SUBJECT: Documentation of Review Findings for the Rio Salado Oeste Ecosystem Restoration Study, Salt River, Maricopa County, Arizona.

Documentation of Review Findings
Rio Salado Oeste Ecosystem Restoration Project, Salt River
City of Phoenix, Maricopa County, Arizona

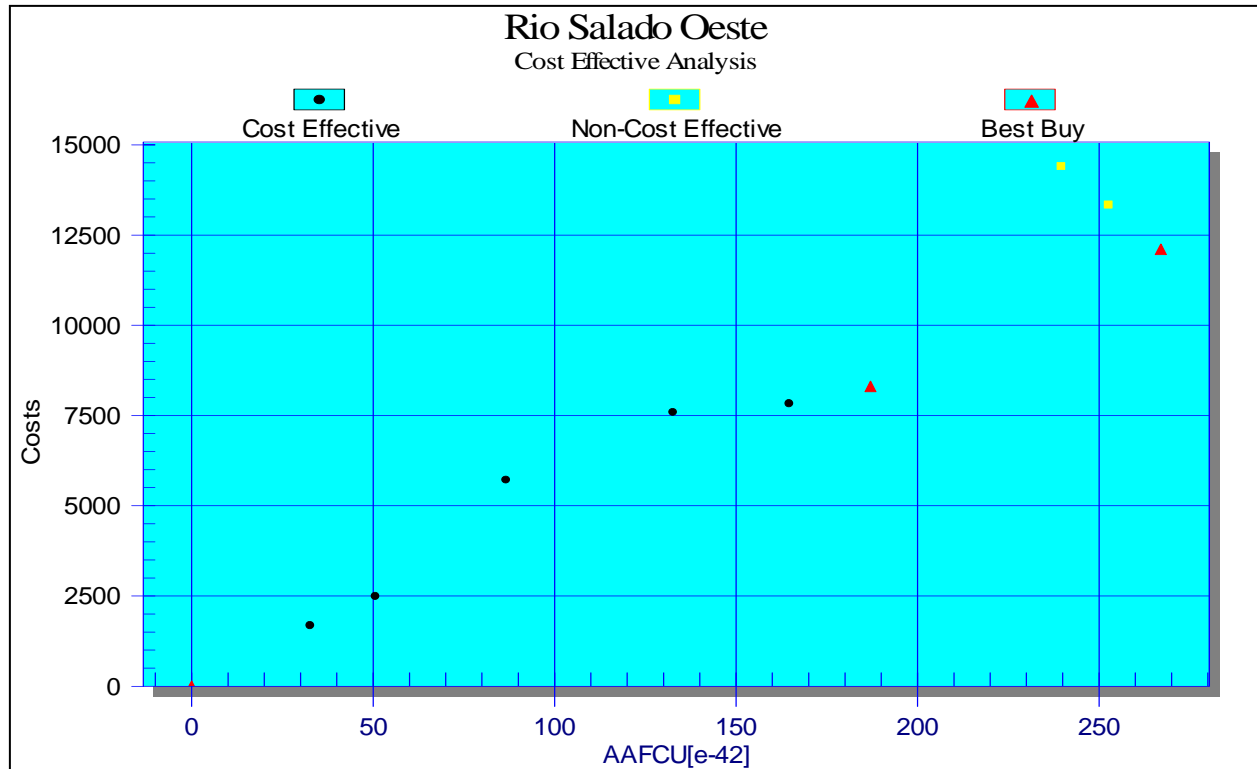
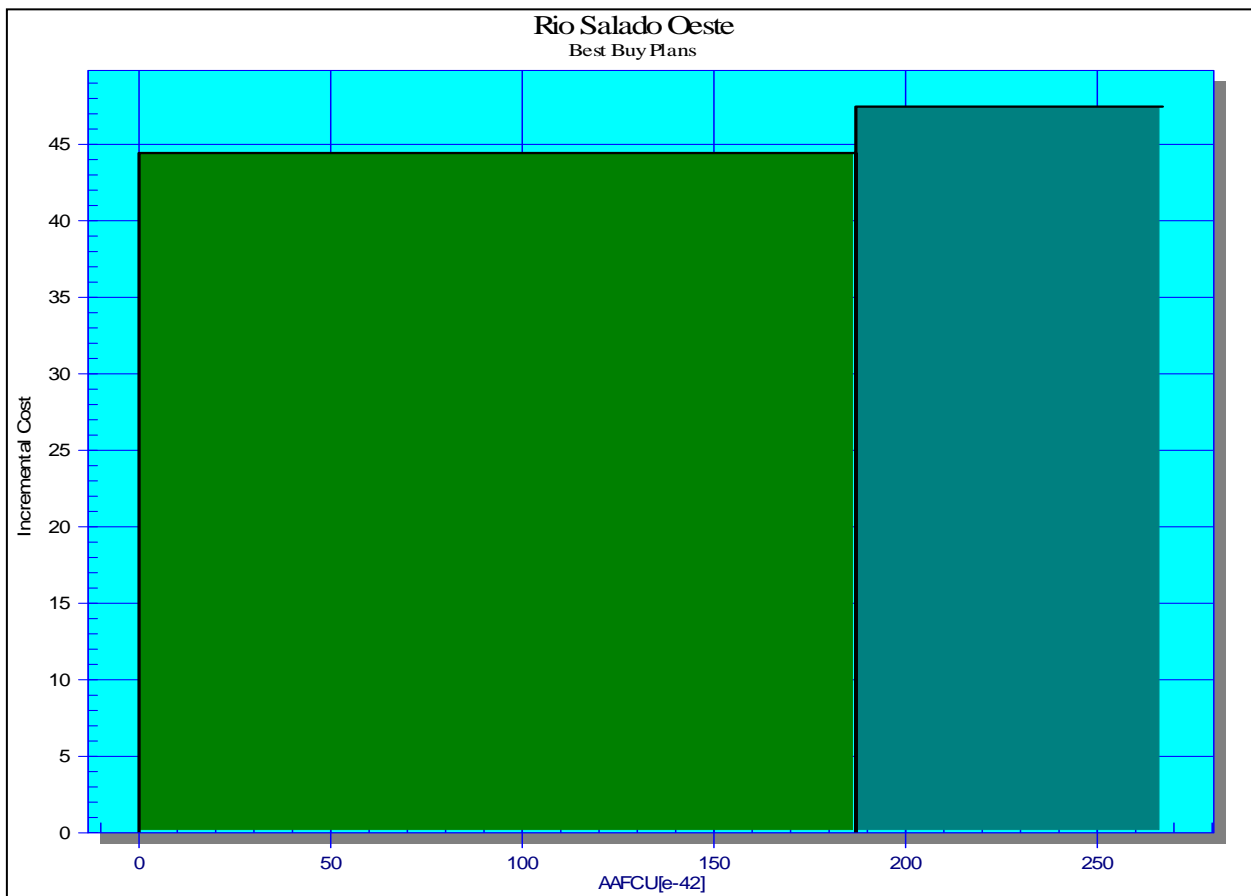
The figure below displays the Cost Effective Analysis as performed using IWR-Plan software. This includes analysis of the original alternatives with the new four refinements. Two alternatives are not cost effective, there are two best buy including the tentatively recommended plan identified previously and refinement 2.

Table 2 and the figure below display the two “Best Buy” plans. In comparing the two plans you can see that the Cost/AAFCU and Incremental Cost/Incremental AAFCU are nearly identical. Alternative 5A provides 42% more AAFCU’s and restores significantly more acreage of scarce and ecologically important cottonwood-willow and mesquite habitats. That includes 171 acres of cottonwood-willow and 307 acres mesquite.
